Proposed Turkey Point Units 6 and 7
Docket Nos. 52-040 and 52-041
FPL Revised Response to NRC RAI No. 02.05.04-18 (eRAI 6006)
L-2014-111 Attachment 17 Page 26 of 26

QUESTIONS from Geosciences and Geotechnical Engineering Branch 1 (RGS1)

FSAR Figure 2.5.4-240 Lateral Earth Pressure Diagram: At-Rest Case At-Rest Earth Pressures Considering a 500 psf Surcharge on Fill

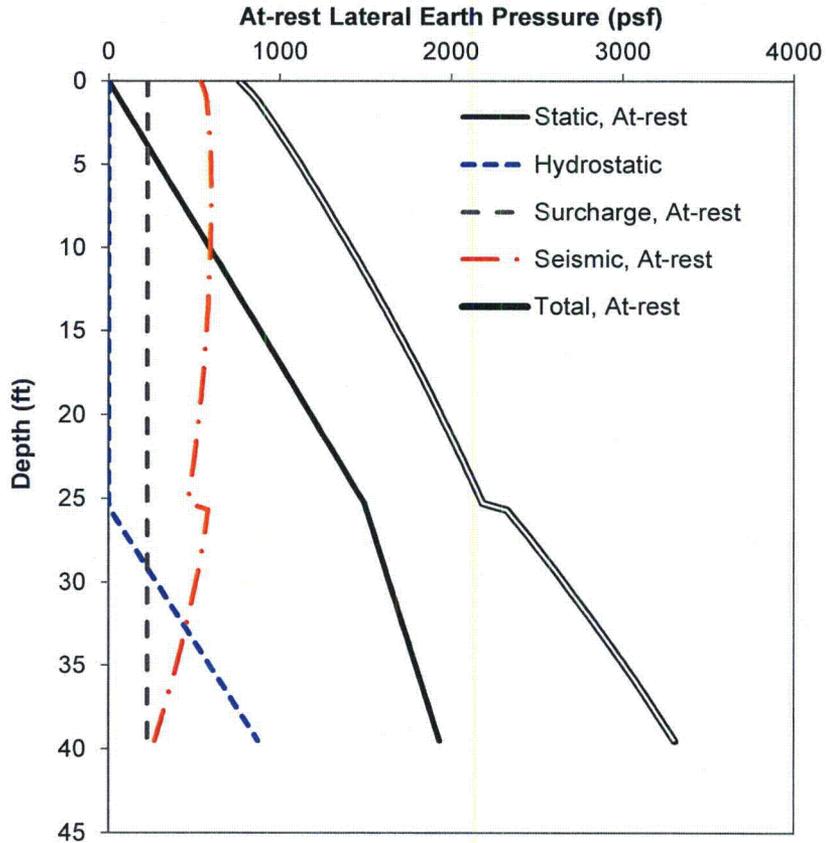
The lateral earth pressure diagram shown in Figure 2.5.4-240 shows a plot corresponding to the dynamic lateral earth pressure. The shape of this plot appears to be consistent with the shape for dynamic pressure considering a rigid structural wall (see ASCE 4). In Section 2.5.4.10.4.2 "Seismic Lateral Earth Pressures", the active seismic pressure was computed using the Mononobe- Okabe equation. The last sentence of the section indicates that at-rest pressure as a function of depth for below-grade walls is developed consistent with Reference 277 (ASCE-4) using the design ground motion. It is noted that the pressure developed using the ASCE-4 methodology uses the z_{pa} value from the input motion.

FSAR Figure 2.5.4-240 will be replaced with the following figure in a future revision:
